ESR Horsley Logistics Park Modification 1

Amend layout of Lots 201 and 204

State Significant Development Modification Assessment (SSD-10436-MOD- 1)

August 2021

Figure 6 | Proposed Lot 201 Warehouse

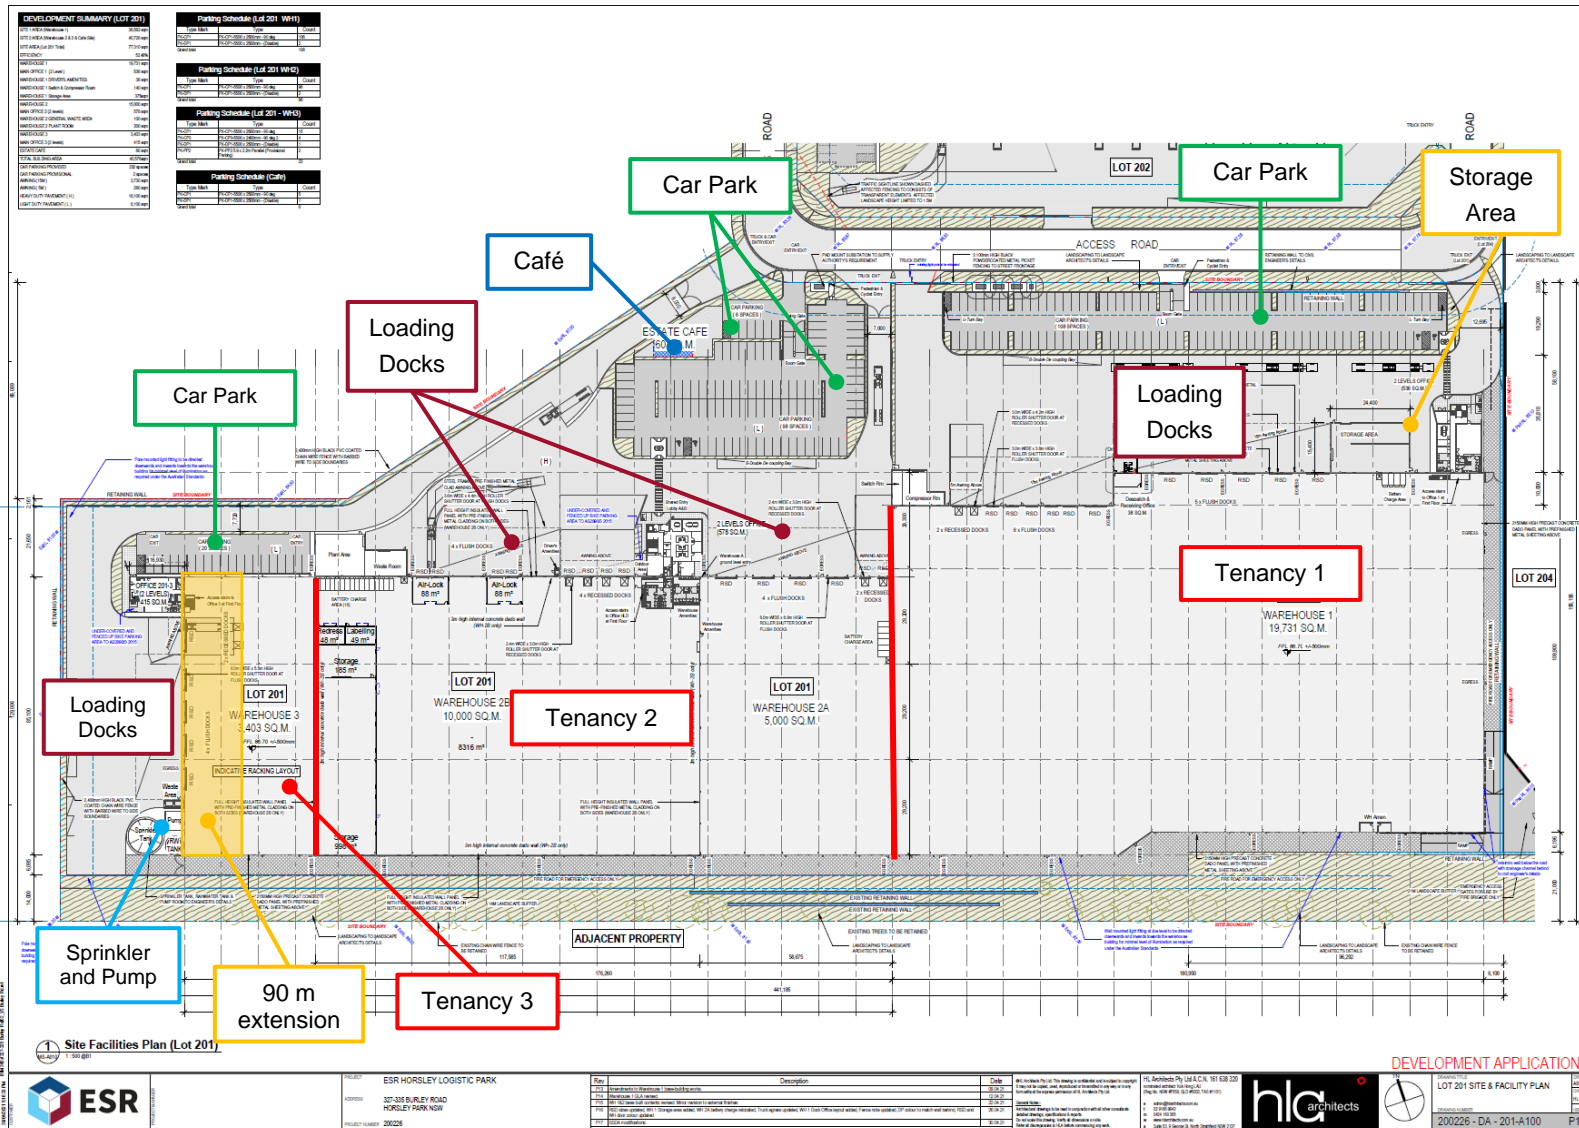
Penrith City Council (PCC) noted the width of the landscape setback to Lot 201 western boundary was narrow and would be insufficient to screen the proposed loading docks located to the west of Lot 201 warehouse building.

PCC raised concerns the western boundary landscape setback was not wide enough to offset the potential visual impact of the proposed loading areas to the west of Lot 201 warehouse building.

PCC raised concerns the width of the landscape setback to the western boundary of Lot 201 and potential visual impacts from the loading docks on the western elevation. The Department notes that a 2 m wide landscaped area comprising trees of a mature height of 30 m are forms part of the approved development. The Department also notes that land to the immediate west of Lot 201 would be future industrial developments within Jacfin Horsley Park development which are less sensitive to visual impacts than receivers to the south. As such, the Department considers the proposed landscaping along the western boundary of Lot 201 to be adequate.

Figure 9 | Southern Boundary Interface Treatments

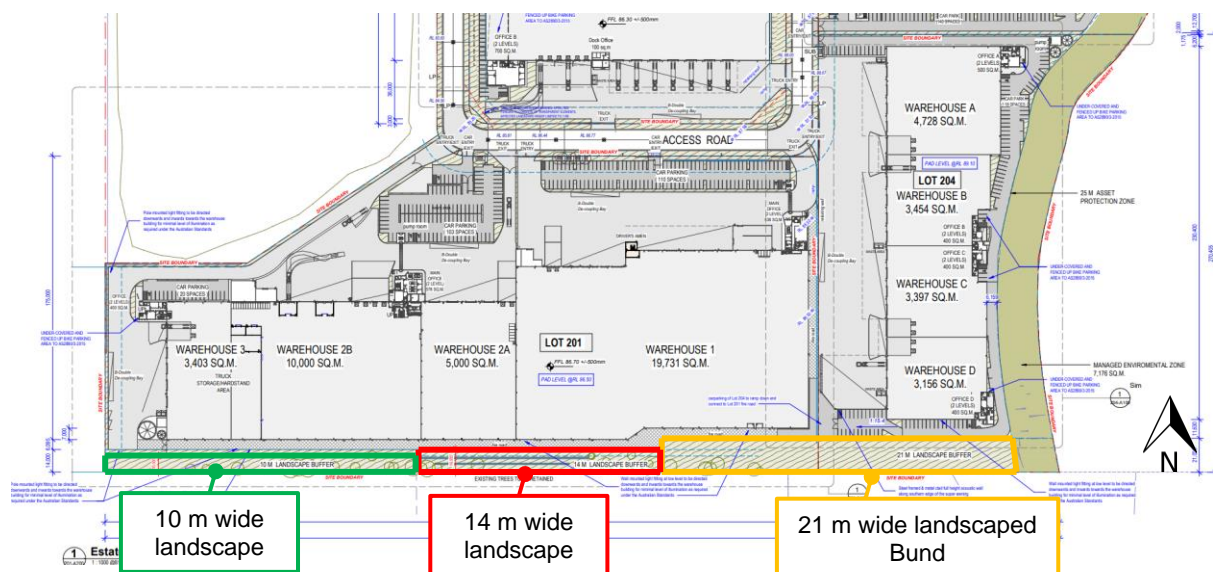
The Department carefully considered visual impacts in its assessment of the approved development and recognised the importance of interface treatments along the southern boundary in mitigating visual impacts to existing and future sensitive receivers to the south of the site.

The proposed modification includes an extension of the Lot 201 warehouse building resulting in a longer southern façade. The Department notes the extension is to the western end of the building, away from the sensitive receivers within Greenway Place and the future Jacfin rural residential lands to the south. Furthermore, the extension is within the confines of the approved western boundary of Lot 201 and

does not extend beyond the western end of the southern boundary interface treatments. The Department therefore considers visual impacts of the proposed modification can be mitigated by the interface treatments constructed along the entirety of the southern boundary under DA 893.1/2013 and embellished under the approved development to achieve an appropriate outcome once landscaping reaches maturity.

The Department recognises there is the potential for increased visual impacts during the interim period until the trees along the southern boundary reach maturity. Again, it is noted the proposed building extension is to the western end, away from the sensitive receivers to the south, towards industrial zoned land. Furthermore, as noted in the Department's assessment of the approved development, the Jacfin rural residential lands are bordered by industrial land to the north and west, and future occupiers would reasonably expect industrial buildings to be visible in those directions.

The early establishment and on-going maintenance of landscaping at the southern boundary is fundamental in mitigating the visual impacts of the proposed modification. During the assessment of the approved development, the Department imposed a condition requiring the Applicant prepare a detailed landscape plan with trees to a height at maturity which would screen the western portion of the Lot 201 warehouse building within the additional 4 m wide area along the southern boundary, prior to commencement of construction. Further, prior to the commencement of operation of any part of the development, the Applicant is required to prepare a Landscape Management Plan to ensure ongoing management and maintenance of all vegetation along the southern boundary. The Department considers the existing condition can ensure adequate screening would be in place to mitigate any additional visual impacts of the proposed modification.
